SUBJECT: SAFETY EVALUATION OF TOPICAL REPORT WCAP-15603, REVISION 1,
"WOG 2000 REACTOR COOLANT PUMP SEAL LEAKAGE MODEL FOR
WESTINGHOUSE PWRS" (TAC NO. MB1714)

SAFETY EVALUATION BY THE OFFICE OF NUCLEAR REACTOR REGULATION

WCAP-15603, REVISION 1, "WOG 2000 REACTOR COOLANT PUMP

SEAL LEAKAGE MODEL FOR WESTINGHOUSE PWRS"

**RHODES REACTOR COOLANT PUMP SEAL LEAKAGE MODEL
FOR "OLD" O-ringS
(BASED ON NUREG/CR-4906P AND NUREG/CR-5167)**

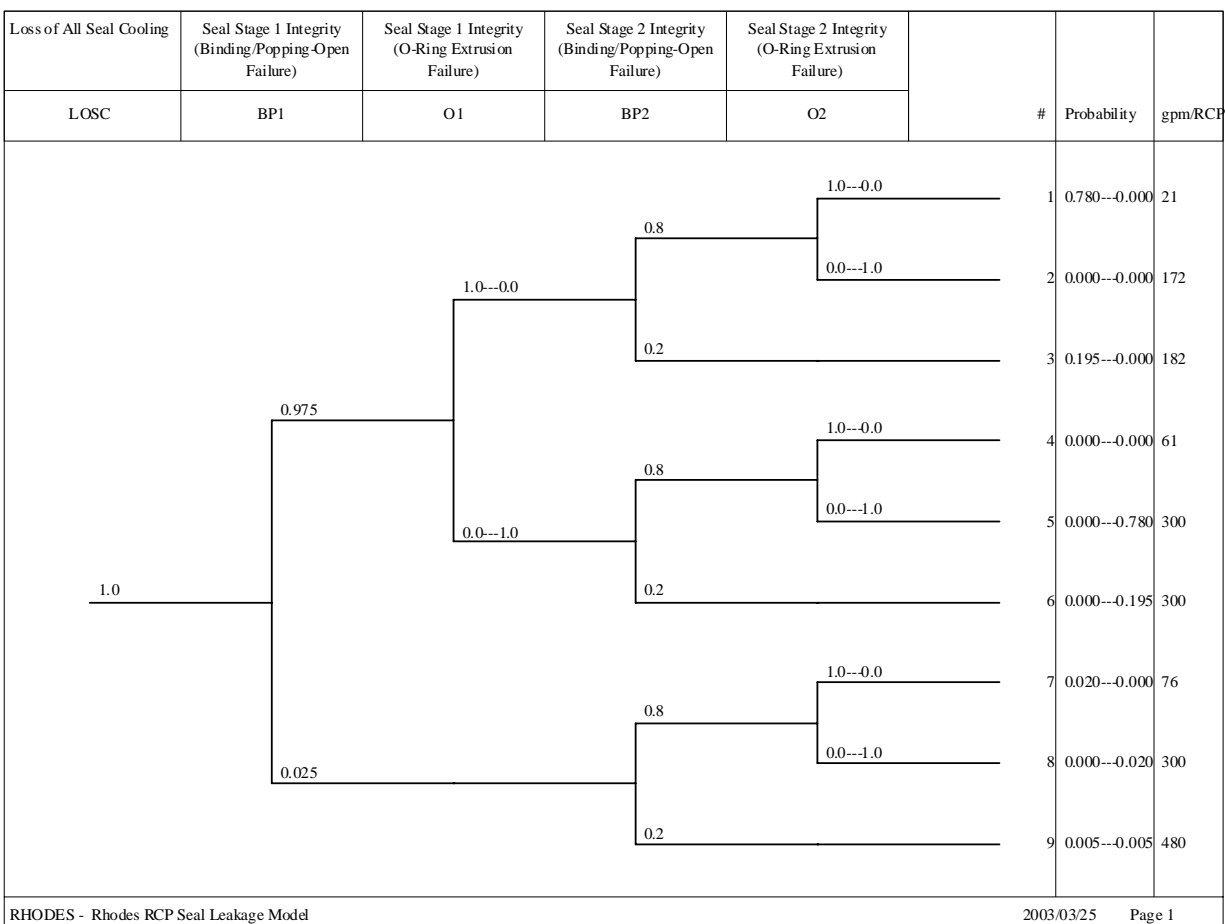
The failure of the third seal stage is not shown since it is assumed to fail (i.e., has a failure probability of unity) if the second seal stage fails and is assumed irrelevant if the second seal stage does not fail. This effectively reduces the Rhodes model from seventeen sequences to nine sequences.

For the first 13 minutes after the loss of all seal cooling, the leakage rate is 21 gpm/RCP (i.e., Sequence 1 with a probability of unity). The probability of O-ring extrusion failure is zero for the first two hours, but is unity after the first two hours. Therefore, after the first 13 minutes and up to 2 hours, the leakage rate is as provided in the figure above with the first probability value given in the figure. After 2 hours, the leakage rate is as provided in the figure above with the second probability value given in the figure.
